GLIDING FEDERATION OF AUSTRALIA

AIRWORTHINESS DIRECTIVE GLIDERS:

GFA/AD/156 GLASFLUGEL/6

SUBJECT: Canopy emergency jettisoning system

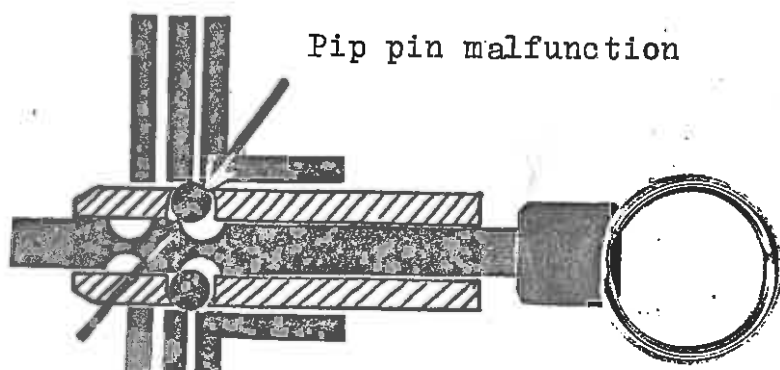
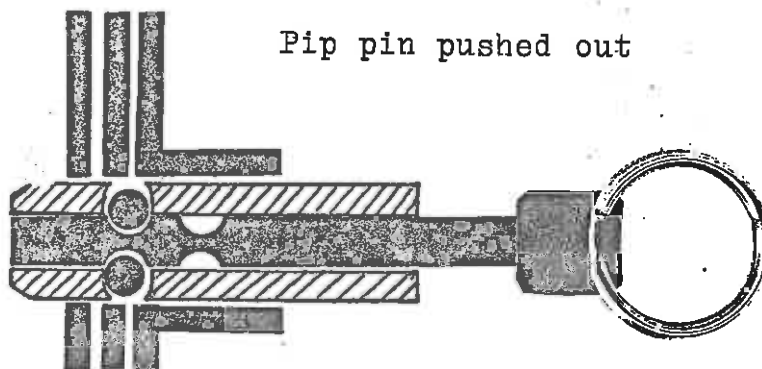
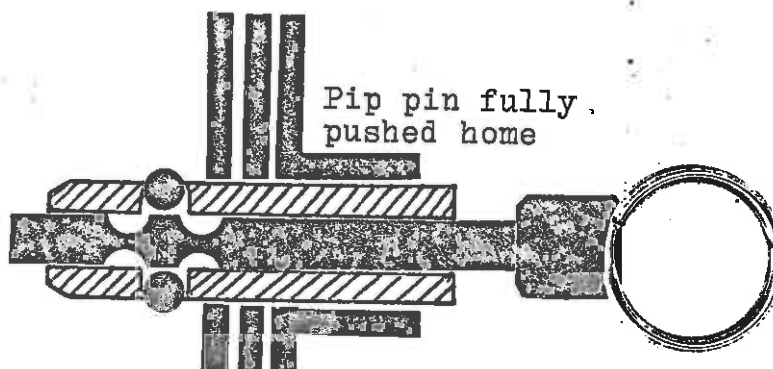
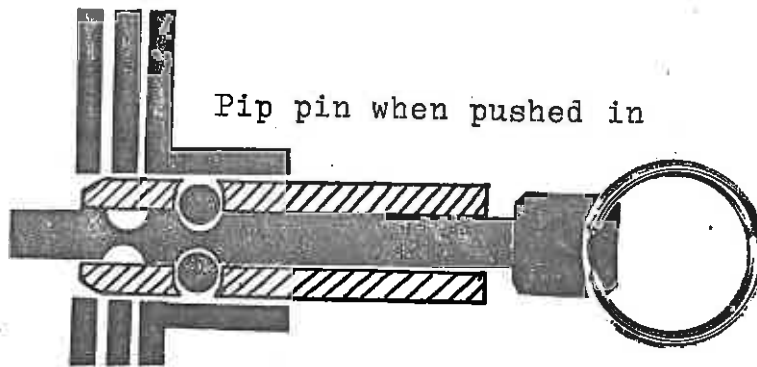
REASON: During a routine check it was discovered that either of the "Pip Pins" of the canopy jettisoning system, which disengage when the red knob is pulled, could become jammed if they had not previously been pushed fully home. (See sheet 2 for illustration of malfunction).

ACTION: On page 19/3.3 of the Flight Manual the following amendment must be inserted -  
"Whenever the canopy emergency jettison knob is pulled and prior to each flight, if no locking thread is used, it should be ensured, that the Pip pins are fully pushed home, so that the locking balls are clear of and behind their fittings".  
(The text is repeated at the foot of this A.D. for owners to cut off and affix to the manual).
